PRODUCTION PROOF

Rev. 1, 14.09.2022

Artnr 100009

RSPEN

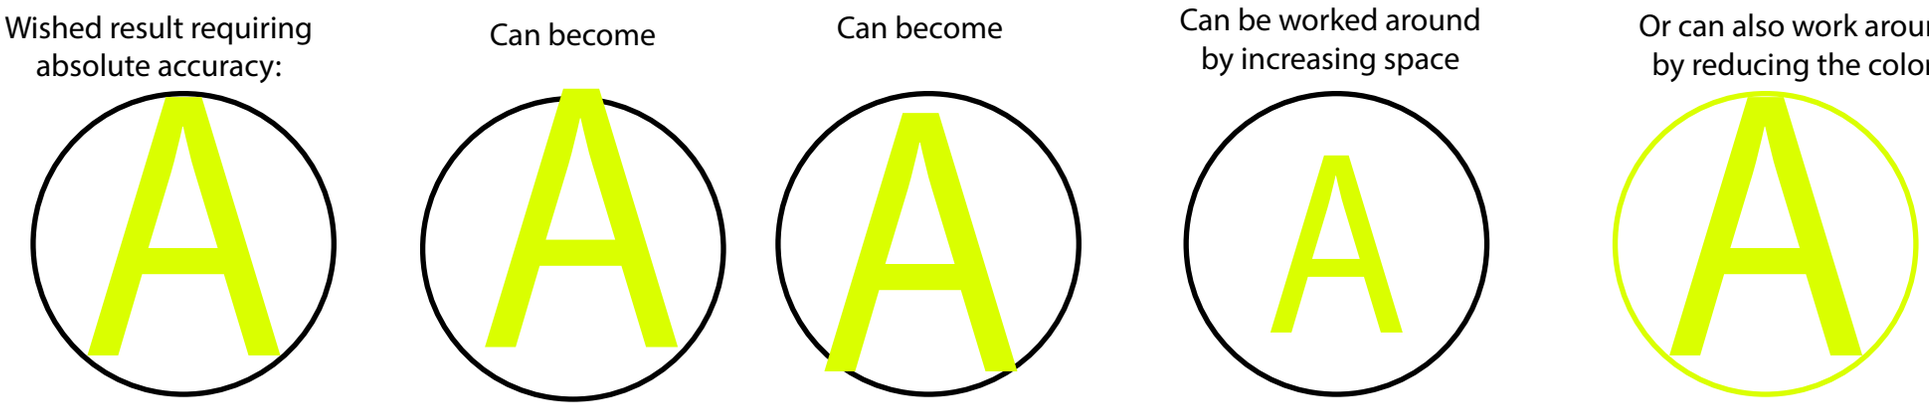
Marking: Pad-print 1-4 colors

Design comments:
-No gradients , colors are solid
-Remember to outline all fonts always
-Letters should be 1mm high for readability, 1.5mm for good readability.
-"absolute accuracy" is not acheivable, Deviation can be 0.5mm between colors as product is moved mechanically between color stations.
In other words: Where deviation in placement of color, even less than 0.5 mm will break the visual appearance of the logo then the logo is not producable.

Place logo inside pink line, 4*1 cm
